December 12, 2012

GPT/Custer Spur EIS
c/o CH2M HILL
1100 112th Avenue NE, Suite 400
Bellevue, WA 98004

Re: Proposed Gateway Pacific Terminal Project

Exhibit A

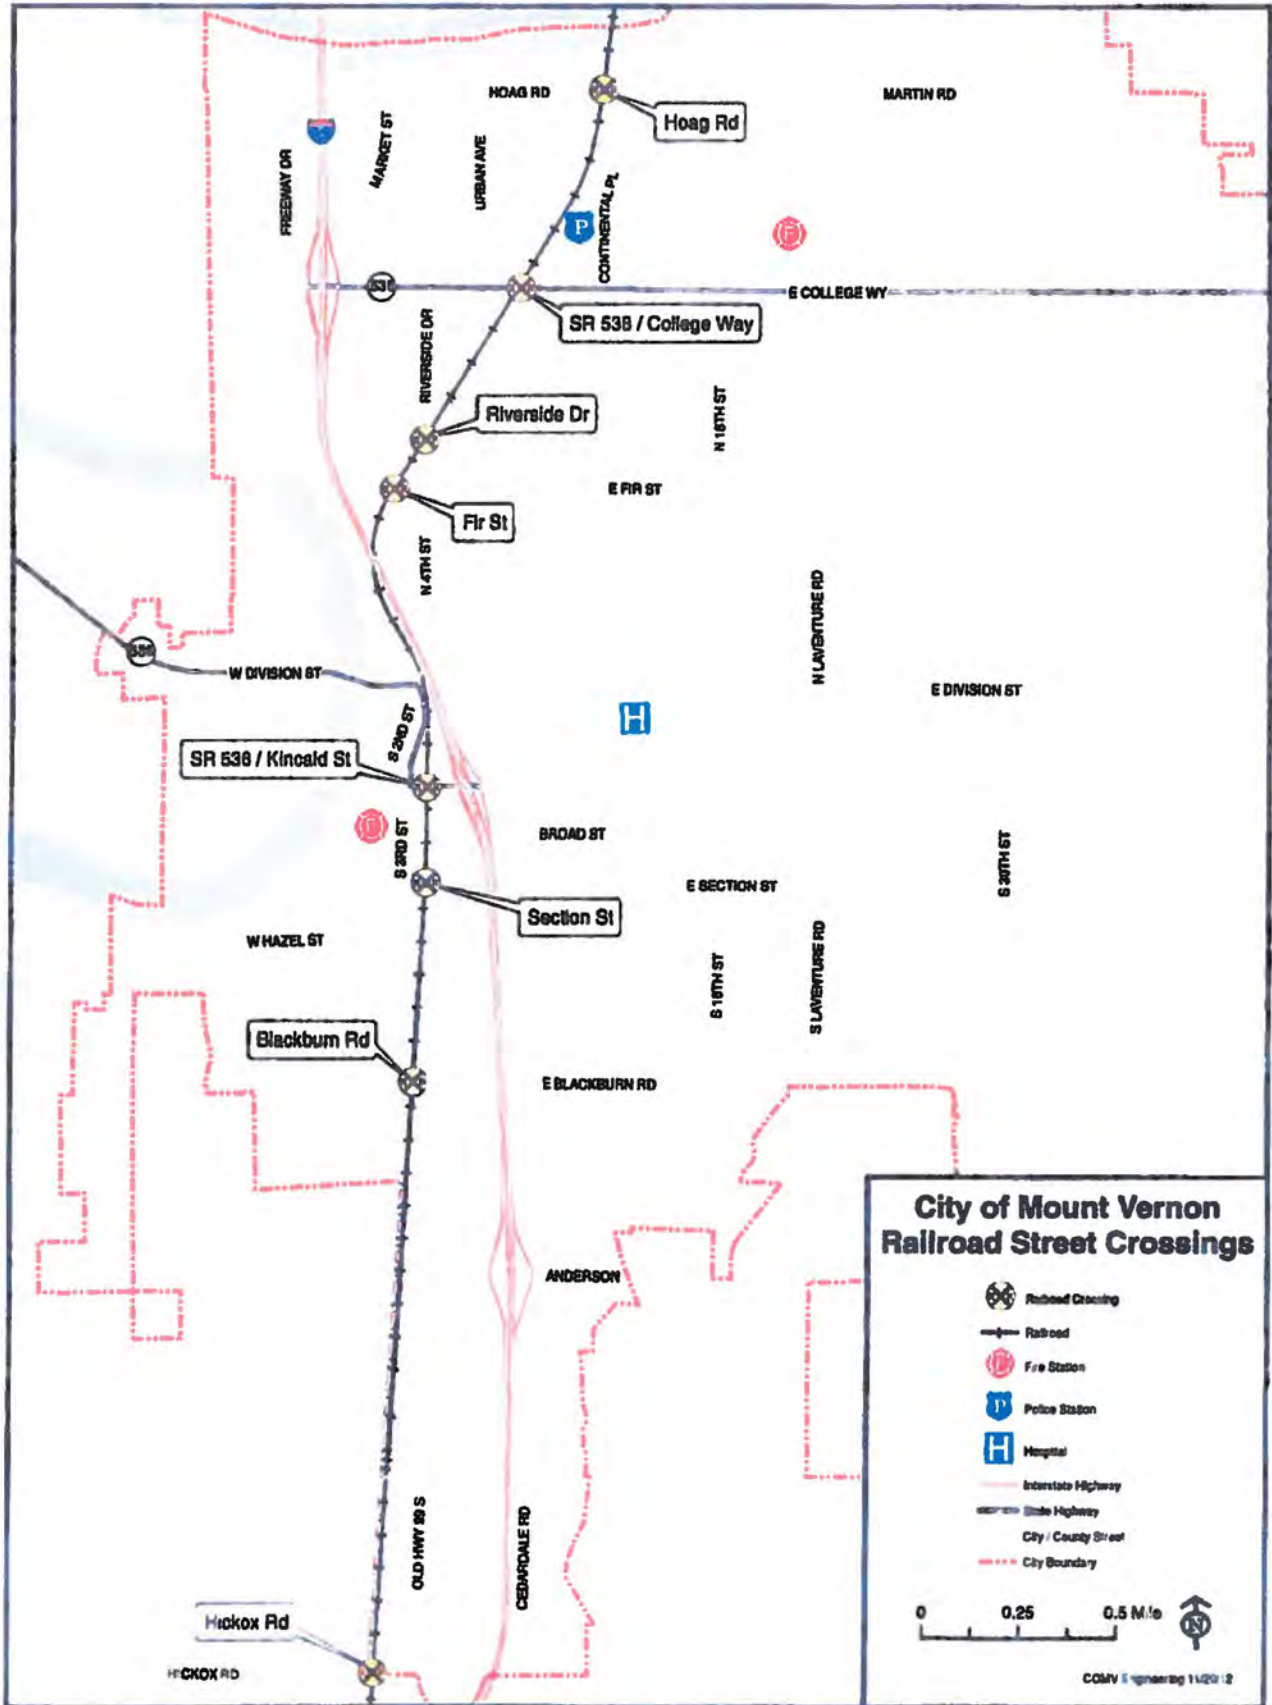
The City contains within its jurisdictional boundaries the BNSF rail line. This rail line has eight at-grade railroad crossings located within the City (two of which cross heavily traveled state routes; **Exhibit A**), one just east of College Way and Riverside Drive, the busiest intersection in the County, and another at Kincaid Street which is at the entrance to Mount Vernon's historic downtown and the location of the County Courthouse, Jail and City Hall. As explained below, it is expected this rail line, including at-grade crossings, will be utilized to serve the Project.

- A complete evaluation and potential mitigation of the transportation impacts to at-grade rail crossings including delays to traffic and emergency response time and impacts to passenger rail traffic at full build out. Reasonable alternatives such as separation of the grade crossing or relocation need to be thoroughly explored.

- *Please refer to **Exhibit A** for all at grade crossings to be examined for impacts and mitigation.*
